Project	IEEE 802.16 Broadband Wireless Access Working Group < http://ieee802.org/16 >	
Title	Correction to Rx SNR, Rx sensitivity, and Tx Relative Constellation Error for OFDM and OFDMA systems.	
Date Submitted	2005-07-08	
Source(s)	Darcy Poulin [SiGe Semiconductor], Paul Piggin [Cygnus Multimedia Communications], Ran Yaniv [Alvarion], Dov Andelman [Intel]	Voice: [613-820-9244 x274] Fax: [Fax Number] dp@sige.com , ppiggin@cygnuscom.com
Re:	IEEE P80216_Cor1_D3	
Abstract	Correction to Rx SNR, Rx sensitivity, and Relative Constellation Error for OFDM and OFDMA systems.	
Purpose	The Rx SNR values in 802.16d are incorrect. As a result, relative constellation error (RCE) and Rx sensitivity are also in error. In addition, there are many inconsistencies throughout section 8.3, 8.4, and 12.4 specifying RCE and Rx SNR. This submission attempts to resolve these inconsistencies.	
Notice	This document has been prepared to assist IEEE 802.16. It is offered as a basis for discussion and is not binding on the contributing individual(s) or organization(s). The material in this document is subject to change in form and content after further study. The contributor(s) reserve(s) the right to add, amen

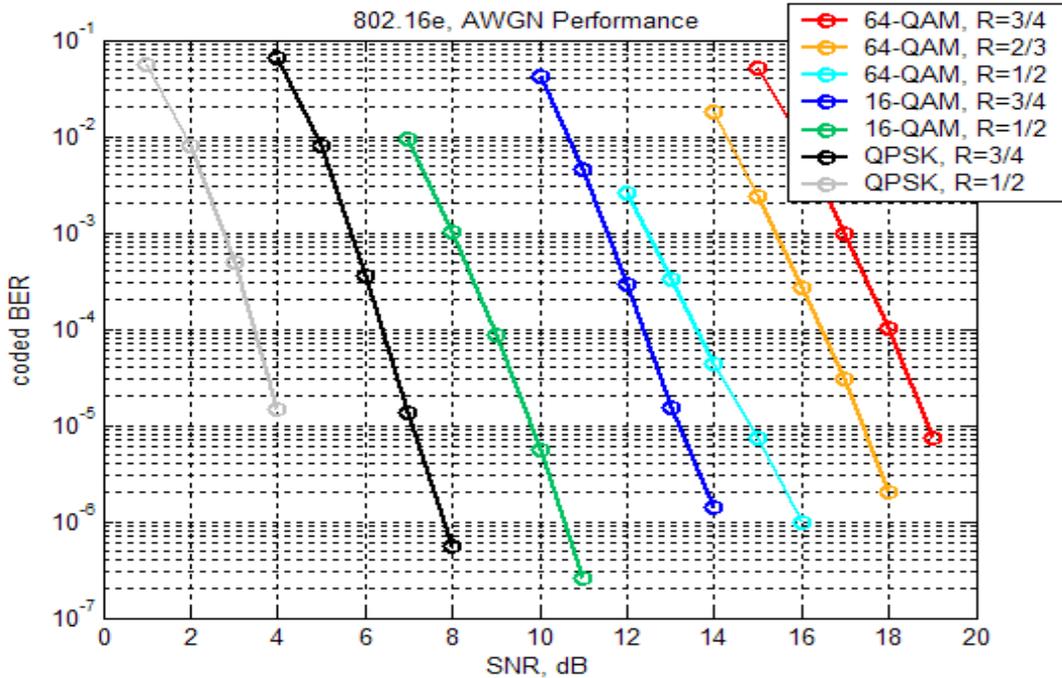
For base stations, we will leave the delta at 10 dB, and put a cap on RCE at -31 dB. This will result in a worst case degradation of the SNR of 1.2 dB for 64QAM-3/4.

BS RCE = SS SNR + SS implementation loss + 10 dB = SS SNR + 15 dB.
This is capped at -31 dB.
